**Sinai Water Resources Study.**  
**Arish-Rafah Groundwater Management Study**  
**Supplementary Report on Recommendations**  
**for Further Investigations (Phase B)**

**Institute of Hydrology**  
**February 1989**  
**5/27D1**

**EEC Project SEM/01/220/022**

Supplementary Report on Recommendations for Further  
Investigations (Phase B)

Figure 2.1

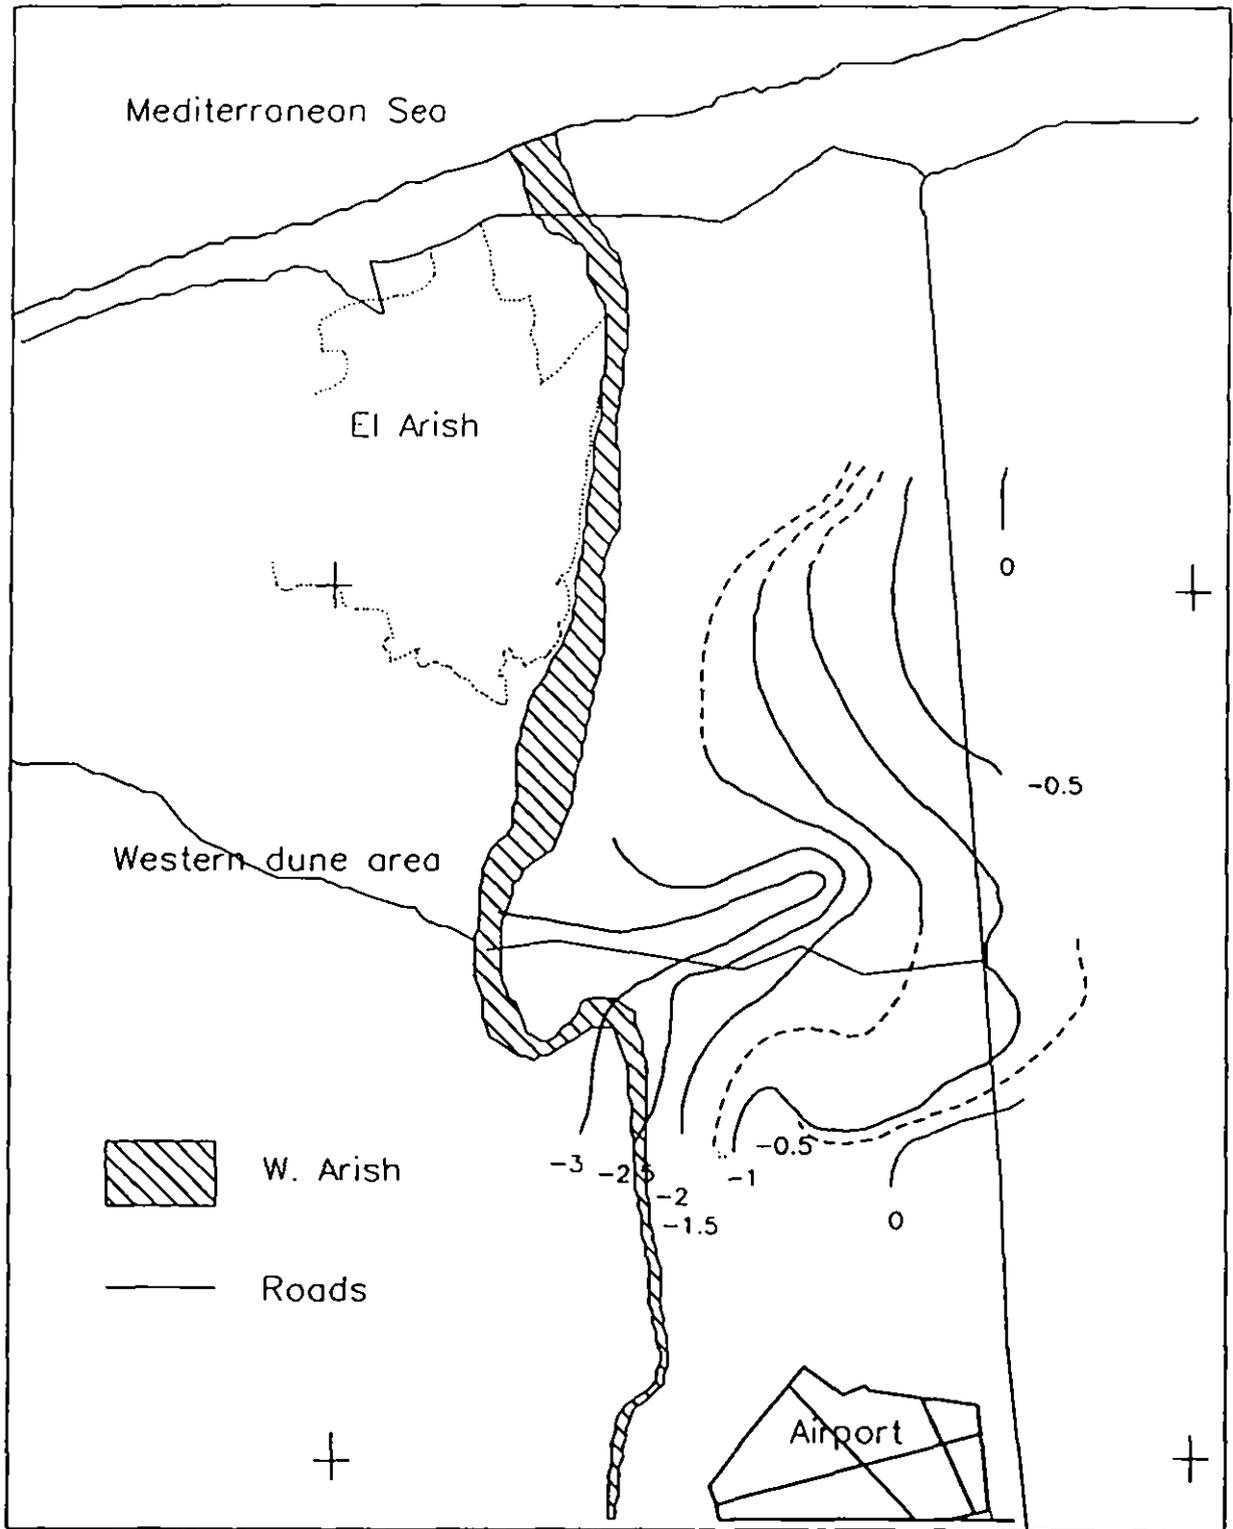
The aquifer area has not been fully defined, but assuming this to be about 28 km<sup>2</sup> (within the zero contour), a storativity of 10% and an average decline in water level of 1.5m since 1981 (Figure 2.1) then the depletion in storage between 1981 and 1988 was 4.2 Mm<sup>3</sup> or 0.6 Mm<sup>3</sup>/y (1644 m<sup>3</sup>/d), assuming no recharge.

The change in salinity between 1981 and 1988 is shown in Figure 2.2, where positive values indicate an increase in salinity. This would generally suggest that water quality has deteriorated in the northern part of the central area. This is more likely to be due to saline intrusion, the greatest increase being along the wadi channel just east of Arish. Aside from a few local areas, the water quality over a large part of the central area has actually improved or has not shown any significant change since 1981 despite the decline in water level (Figure 2.1).

Figure 2.2

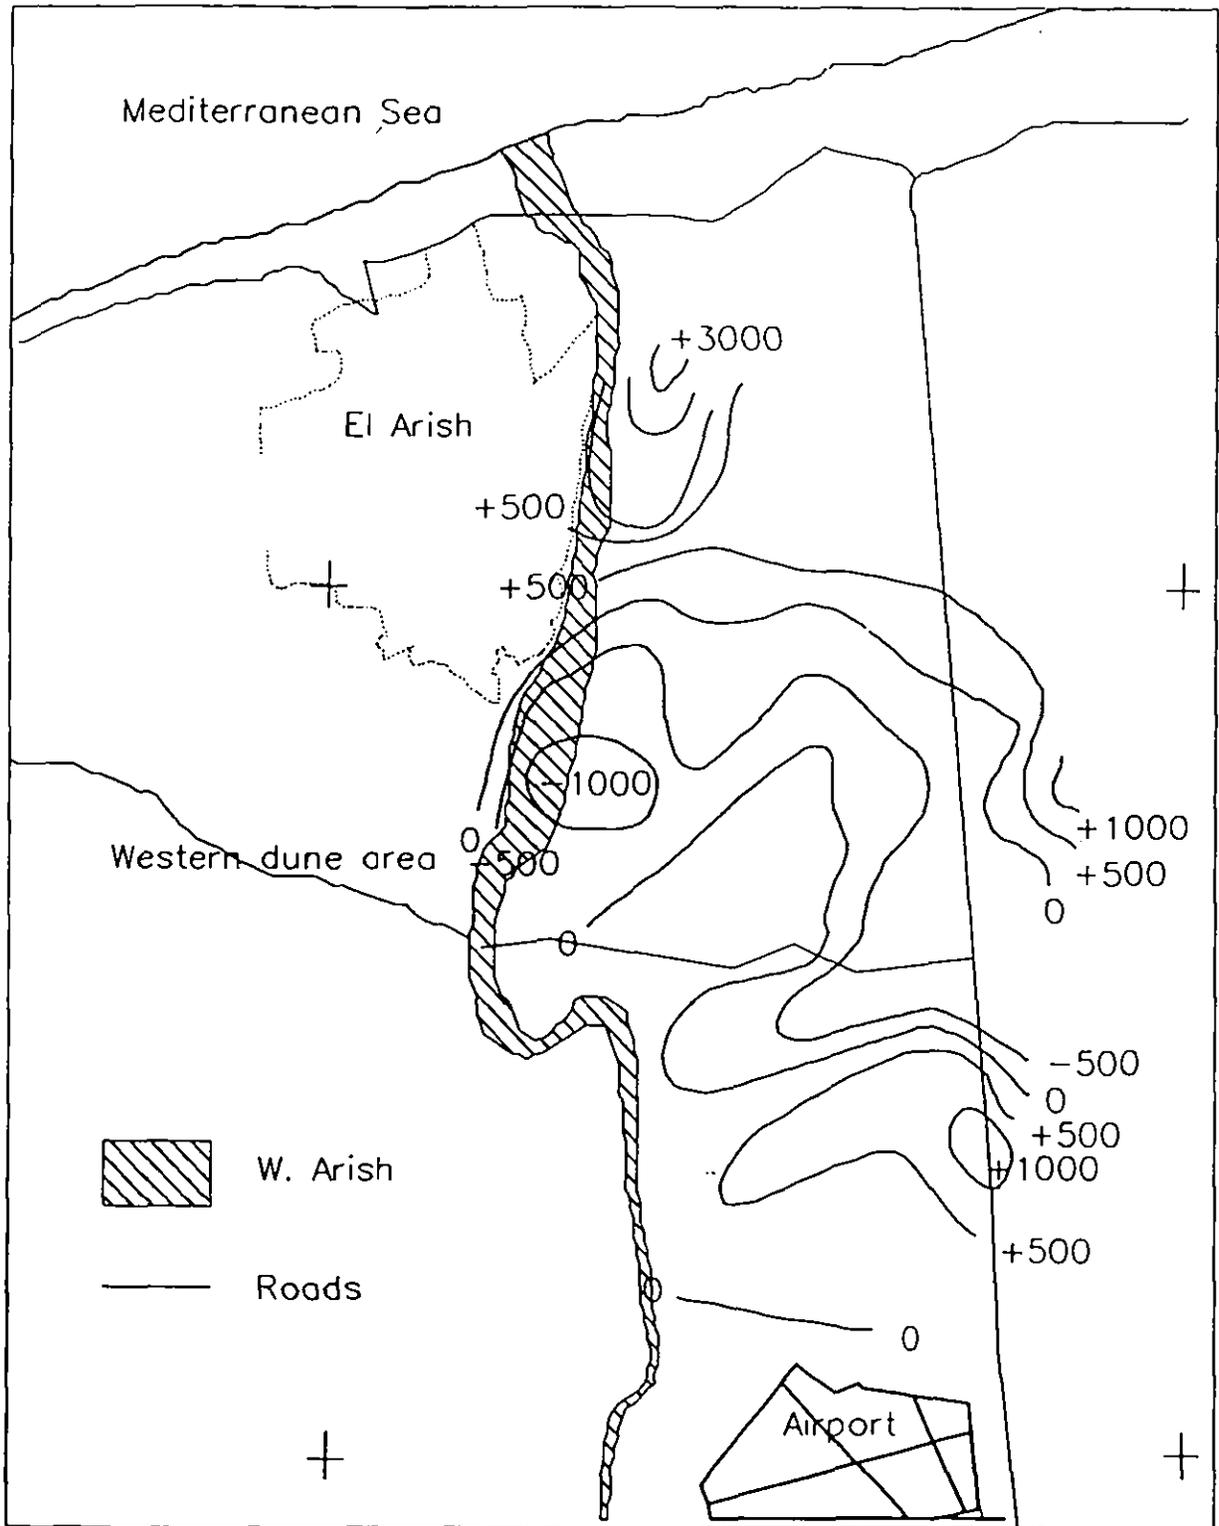
These results indicate that abstraction in the central area is causing a decline in heads which has resulted in inflow from the surrounding area and hence the water quality change will be related to the different water quality in the surrounding areas. Thus those sites in the north would be affected by saline intrusion, those to the east by poorer water in the eastern dune areas (with slightly better quality water along the Wadi Mazar), those in the south by good quality water entering as inflow along the alluvium of the Wadi Arish, and those in the west by reasonable quality water entering from the western dune area. Detailed hydrochemical studies should be able to identify the
